April 7, 2025

It is our understanding that the following comments were provided to Franz Kraintz at the City and County of Honolulu, Department of Planning and Permitting, Community Planning Branch after review of the initial Hawaiian Memorial Park Expansion permit application submittal package. Please note these plans were preliminary at that point in time and remain in development as the plans continue to be reviewed by the City and County of Honolulu at this time. Final plans have not been issued for signature by the City and County of Honolulu as of the date of this letter.

Regarding comments provided, please see the attached responses:

The associated drainage maps are presented below:

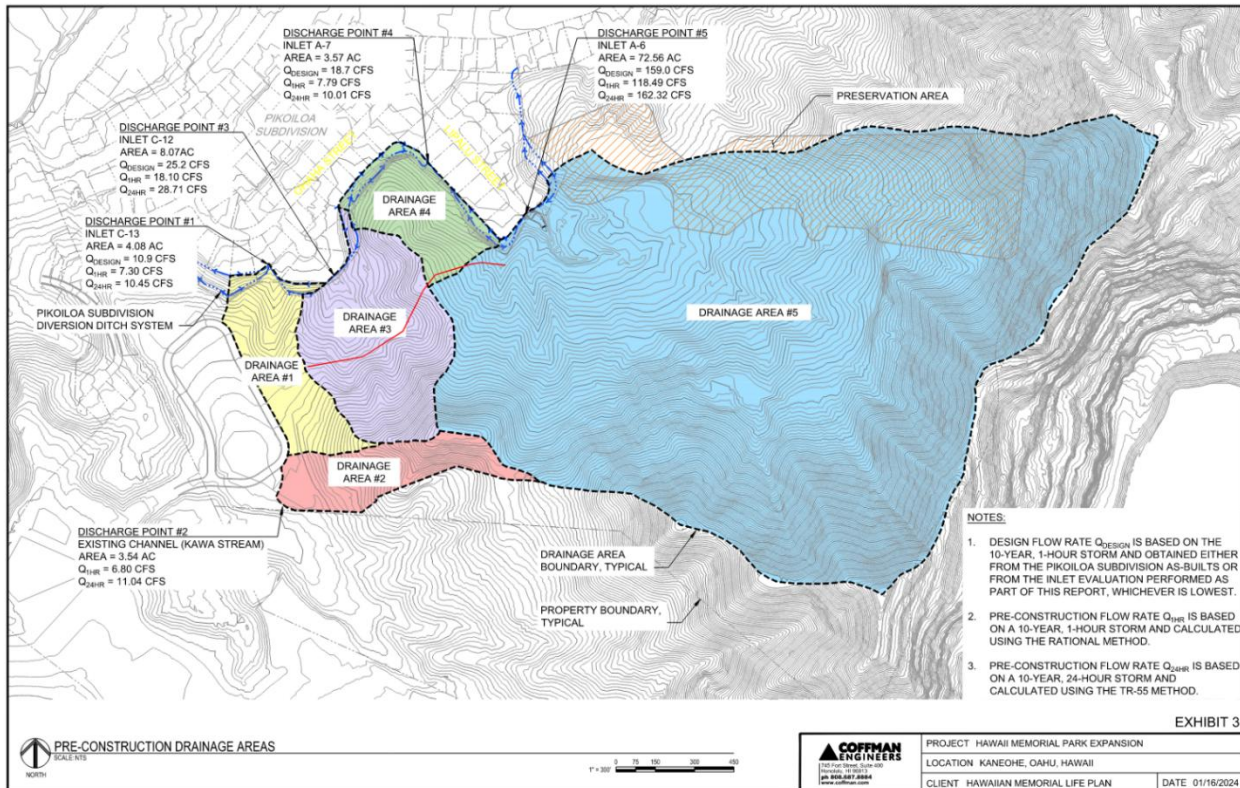
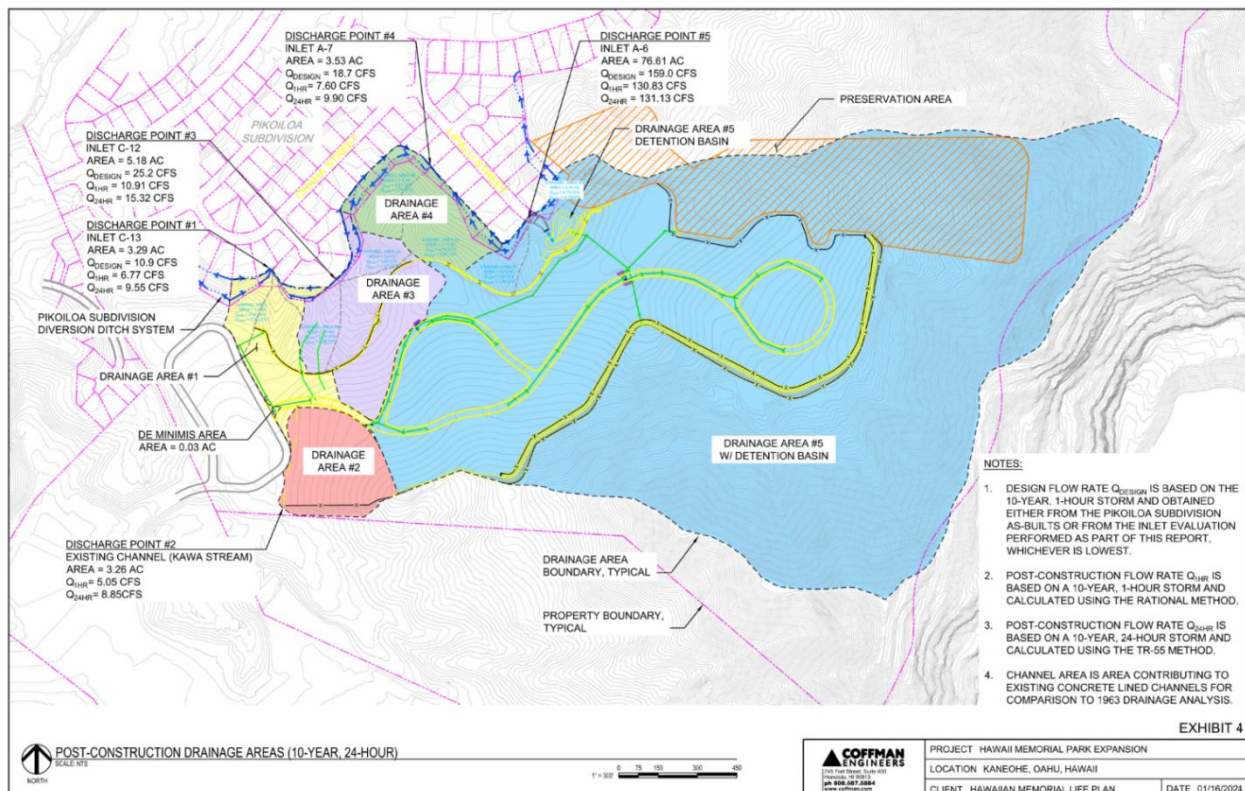
3. Isn't DPP's current practice to require proposed developments not to exceed the predevelopment runoff? If so, shouldn't this development be required to limit the post development runoff to 106 cfs? Allowing what would be a little over a 50% increase in runoff in this area where flooding is already a concern doesn't seem appropriate to me. (I did not see any calculations in the Drainage report that showed the runoff from the 10-yr , 1-hr storm from the Pre-Development site, so I used the figure from the PER.)

Current analysis from the Drainage Report and Detention Basin Analysis, dated October 2024, shows that a 10-year, 1-hour storm for the existing condition is expected to generate approximately 151.70 cfs that would leave the site and be directed toward receiving inlets near the back of the Pikoilua Subdivision. The same analysis for a 10-year, 24-hour storm as requested by the intervener, shows that the existing condition is expected to generate 211.46 cfs that would leave the site and be directed toward the receiving inlets near the back of the Pikoilua Subdivision.

Related to the development of a site and hydrologic criteria, Storm Drainage Standards by the Department of Planning and Permitting, City and County of Honolulu dated August 2017, Part I – Hydrologic Criteria, Section B, Subsection 3, states that “For drainage areas where downstream capacities are inadequate to accommodate runoff quantity identified above, runoff shall be limited to pre-development conditions or as specified in the General Conditions.”

To comply with this condition, Pikoilua Subdivision as-builts were obtained and design runoff rates to the Pikoilua Subdivision were researched. Based on the as-builts for the subdivision, the Pikoilua drainage system was designed to accept a combined total of 259.1 cfs (10-year 1 hr storm) of runoff from the contributing areas upstream of the four receiving inlets located behind the homes and roads of the Pikoilua development. Drainage analysis shows the proposed flows from the

proposed Hawaii Memorial Park Expansion to each existing inlet will be less than the existing Pikoilua drainage system was designed to accept. The total runoff from the proposed Hawaii Memorial Park Expansion contributes 151.70 cfs (10 year-1 hr storm) to the four existing inlets behind the homes and roads in the Pikoilua Development.

To summarize findings in the Drainage Report and Detention Basin Analysis, dated October 2024 see the table below:
